# **INTERNATIONAL CODE COUNCIL 2012/2013 CODE DEVELOPMENT CYCLE Group A (2012)**

## **PROPOSED CHANGES TO THE 2012 EDITIONS OF THE**

**April 29<sup>th</sup> – May 8<sup>th</sup>, 2012  
Sheraton Dallas Hotel  
Dallas, TX**

**FIGURE 722.5.1(3)**  
**GYPSUM WALLBOARD PROTECTED STRUCTURAL STEEL COLUMNS WITH STEEL**  
**STUD/SCREW ATTACHMENT SYSTEM**

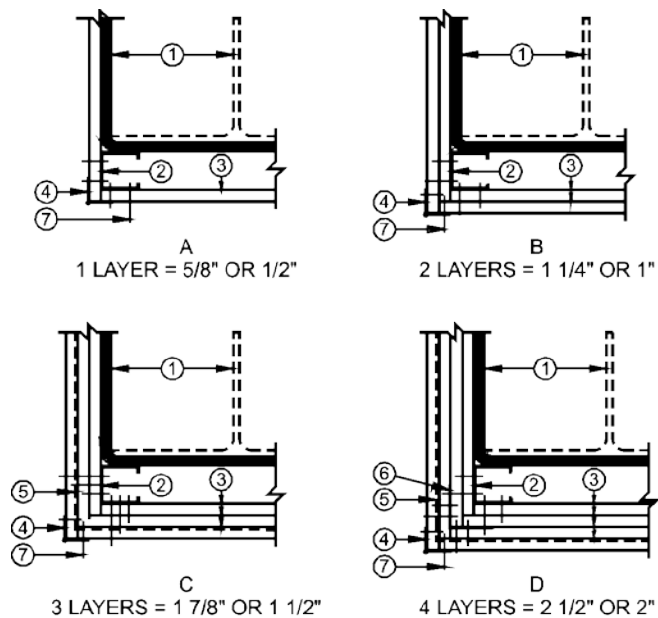
**722.5.1.2.1 Attachment.** The gypsum ~~wallboard~~ board or gypsum panel products shall be supported as illustrated in either Figure 722.5.1(2) for fire-resistance ratings of 4 hours or less, or Figure 722.5.1(3) for fire-resistance ratings of 3 hours or less.

**FIGURE L102.3**

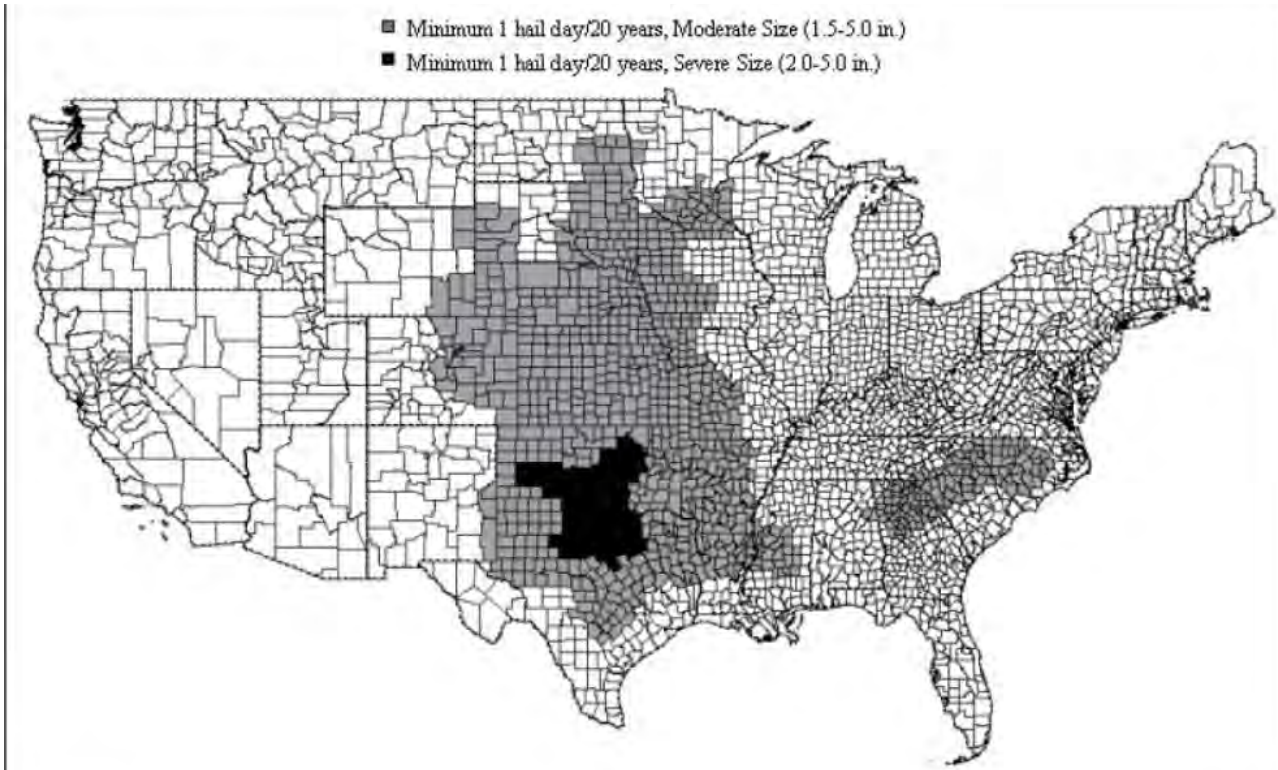
**L102.3.1 Hail Exposure regions.** Hail exposure regions in Figure L102.3 shall be as follows:

**L102.3.2 Exterior wall coverings subject to hail exposure.** Wall coverings used in regions where hail exposure is Moderate or Severe, as determined in accordance with Section L102.3.1 and Figure L102.3, shall be tested, classified, and labeled in accordance with UL 2218 or FM 4473.

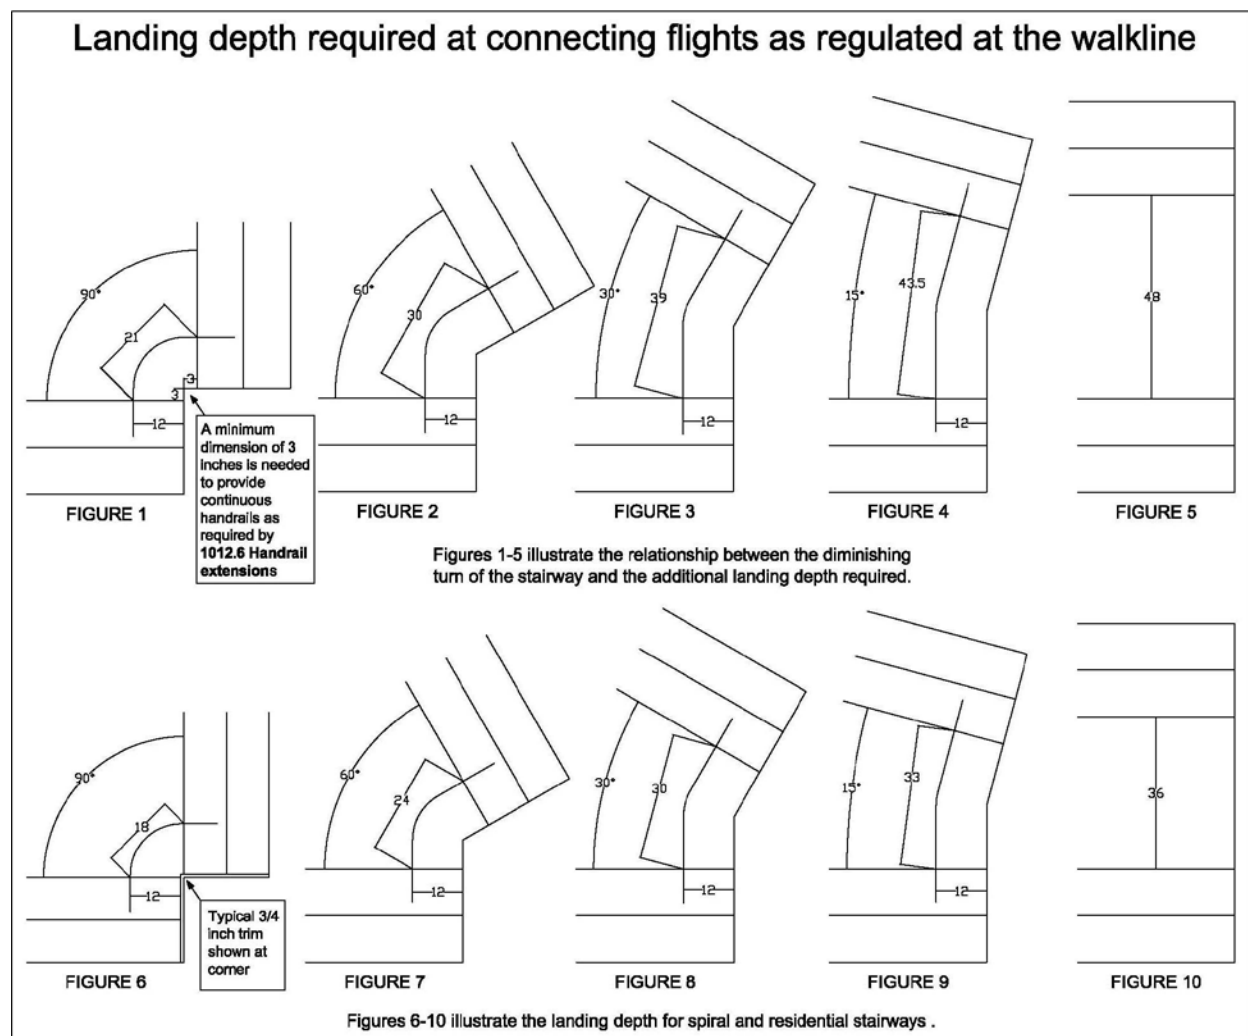
As illustrated in Figures 1 - 10 this proposal requires the landing depth increase as the angle of the turn diminishes to prevent overstepping of the landing and allow the space required to negotiate the turn. This correlates with the 48 inch "need not to exceed" depth of landings specified for stairways with straight runs currently in the code. Figure 1 and 6 shows a minimal 90 degree landing as built in accordance with the code. The landing in figure 1 has the minimum dimension necessary to provide for the continuous handrail connection as required in **1012.6 Handrail extensions**. The minimum landing currently possible has a depth at the walkline as shown of 21 inches and is the minimum allowed by this proposal for a landing turn of 90 degrees. Since the code currently has a "need not exceed limit" of 48 inches applicable to the condition where the stairway is straight run a simple linear relationship between these two conditions allows for calculation of the data in **Table 1** increasing the landing depth by a constant increment as the turning decreases. Figures 2-5 clearly illustrate examples from the table.

Figure 6 shows a typical residential landing and figures 7-10 again illustrate examples from the table and the incremental increase needed for both spiral stairways and residential applications.

**Figure 1** Residential Range = 7.58" (193mm) – 7.74" (197mm), Commercial Range = 6.84" (174mm) – 7" (178mm) see Table 1  
Please note that the described circled ranges have been added to figures 1&2 by the proponent for the purpose of explanation.

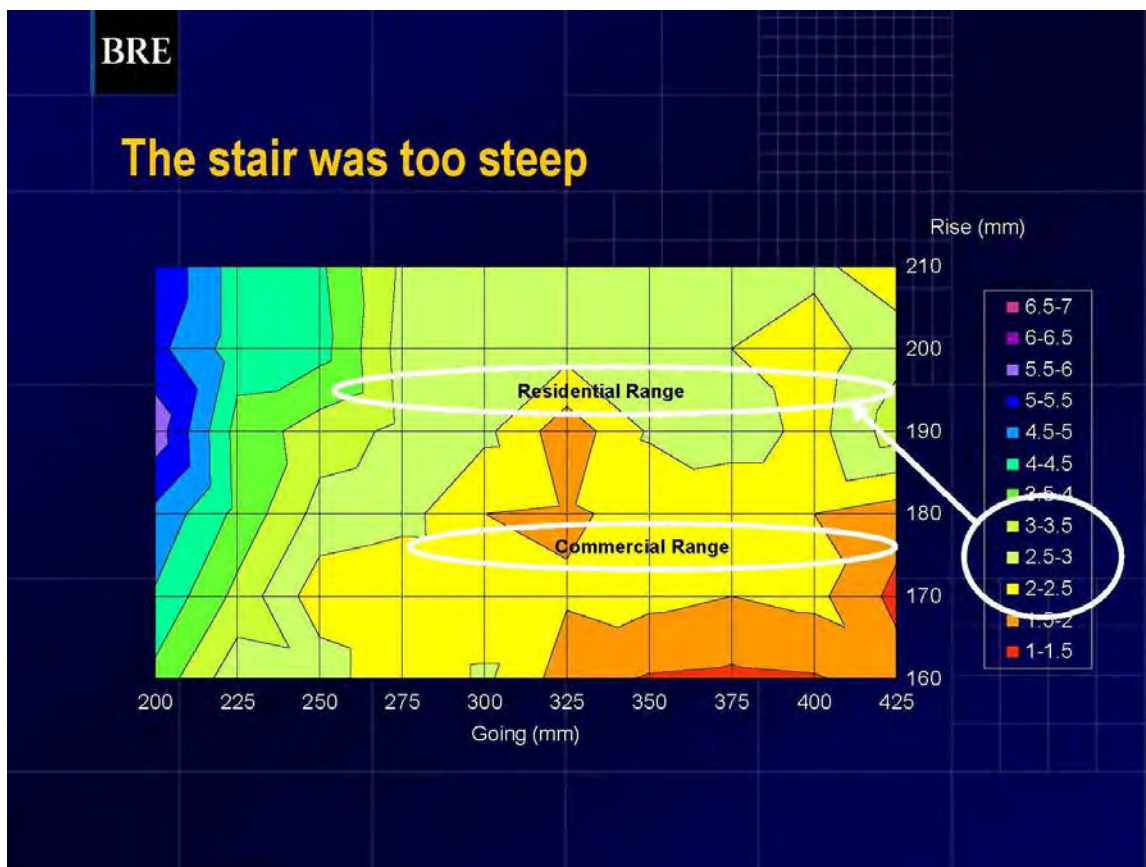
**Testing in support of this proposal**, as shown in the data presentations (Figure 1 and 2) from: "The Influence of Rise and Going Combinations on Stair Safety" by M S Roys, June 2004, 7th World Conference on Injury Prevention and Safety Promotion, Vienna<sup>1</sup>, the minor variation in rise does not produce any consequential effect that can be noticed by users when comparing riser heights within the range in question. *Please note that the circled ranges have been added to figure 1 & 2 by the proponent for the purpose of explanation.* Figures one and two can be related to the perceived energy required in ascent as described by the subjective rating of the steepness of the stair and the need to pull oneself up the stair using the handrail. In these figures the user's ratings are on a scale of 1-7 and color coded. The visual display of the data shows little difference in the users ratings over the range in question.

**Figure 3**  
1.5 X Width Inner  
Radius

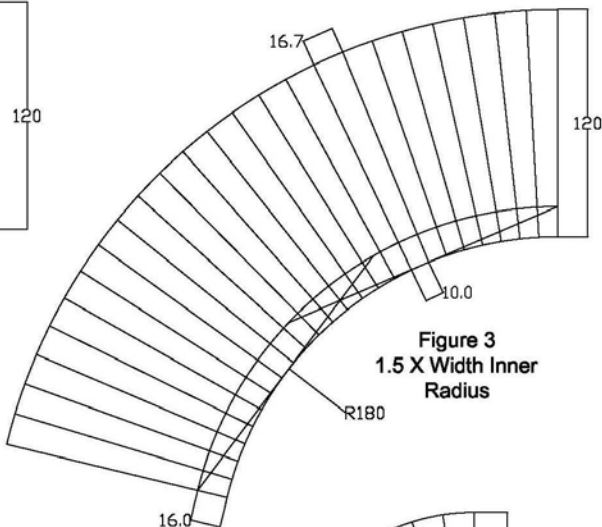
Figures 3 & 4 show the proposed minimum radius restriction of 1-1/2 the width of the stair and a minimal increase in the outside tread depth that causes no change in the margin of safety.
